Agenda – Appeal Committee – January 14, 2026

Item No. 3 Appeal – Variance – 778 Walker Avenue
(Fort Rouge-East Fort Garry Ward)
File DAV 194142A/2025D [c/r DASZ 35/2025]

Title: DAV 25-194142\D – 778 Walker Ave

Issue: For consideration of a Variance associated with the development of a townhouse building with 5 residential suites.

Figure 2: Zoning of the site and surrounding area.

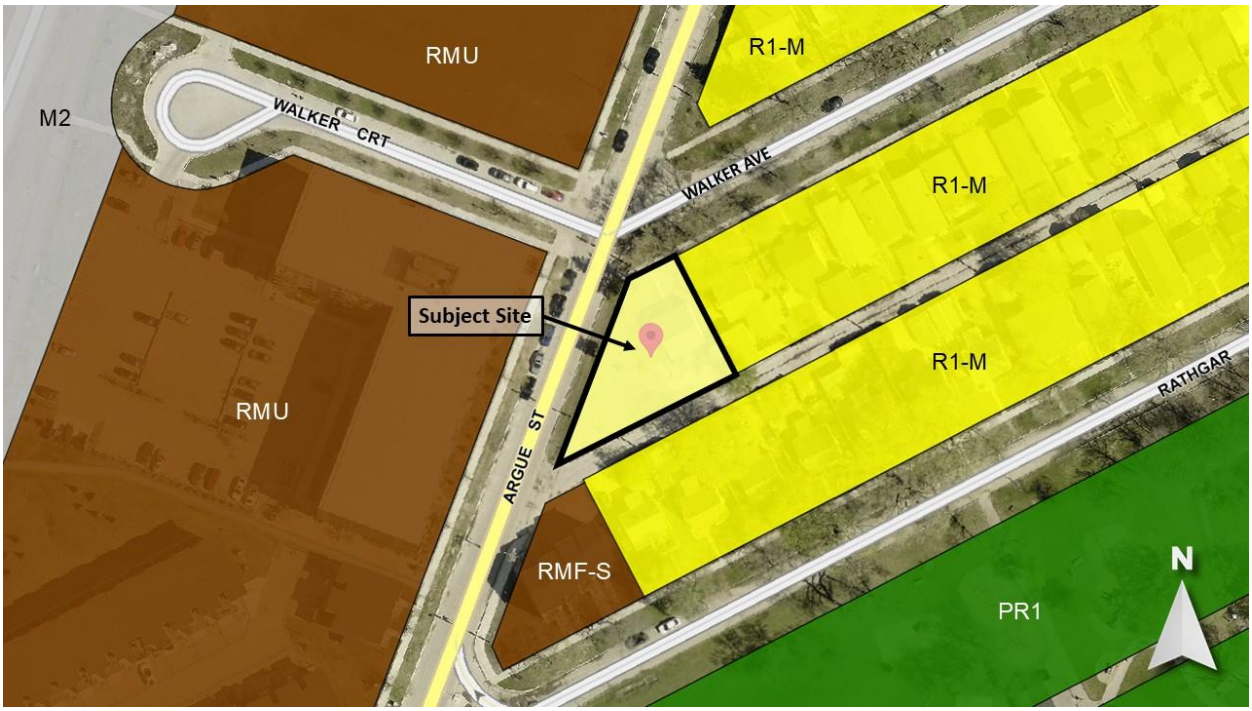
SURROUNDING LAND USE AND ZONING (See Figure 2)

North: Walker Ave, then single- and two-family homes zoned “R1-M” – Residential Single-Family (Medium).

South: Rear lane, then a 4-unit multi-family building zoned “RMF-S” – Residential Multi-Family (Small) and single-family homes zoned “R1-M” – Residential Single-Family (Medium).

East: Argue St, then townhome and multi-family buildings zoned “RMU” – Residential Mixed Use.

West: Single-family homes zoned “R1-M” – Residential Single-Family (Medium).
